Material: 23/32" Plywood .719" [18.3mm]
 Diquinto martino's box dimensions (int.):
 800mm x 410mm x 670mm
 Jan 07, 2017

THAM15_Fornom_Mod_2_martino.dwg - here: Additional notes and driver areas as per drawing provided by 17, 2017

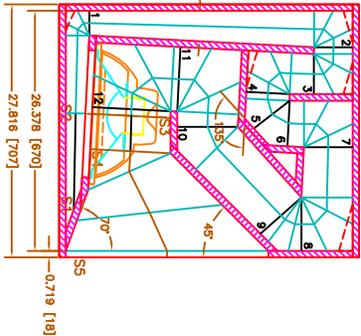
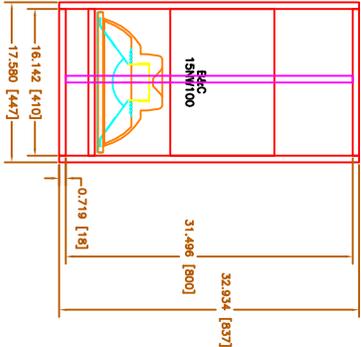
Some suggestions for braces.

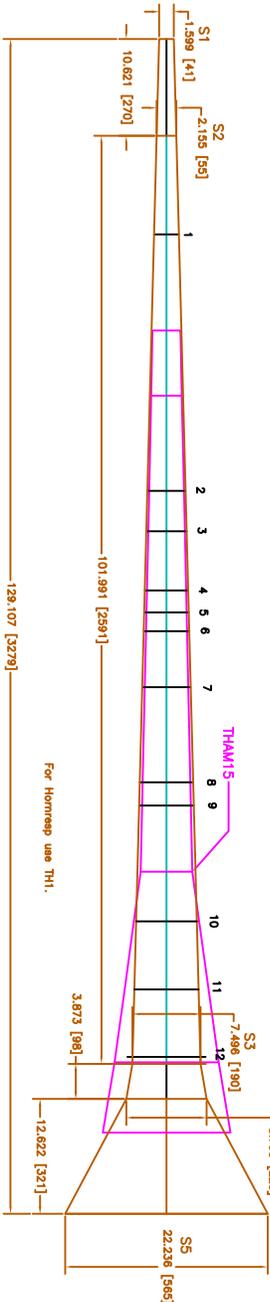
Maximum excursion ~225mm to horn path if cone compensation is applied all the way to the horn. If not, the horn will provide outside (relief) for the cone compensation to prevent bottoming of the driver. The increase area @ S2, and decrease S4.

For TRYS: Change expansion angle to 3°, and create compensation relief from the horn. Add .1" to the duct height @ S2 for bracing.
 Martino_THAM_SS15_Rev01_2017Jun19_TRYS.dwg
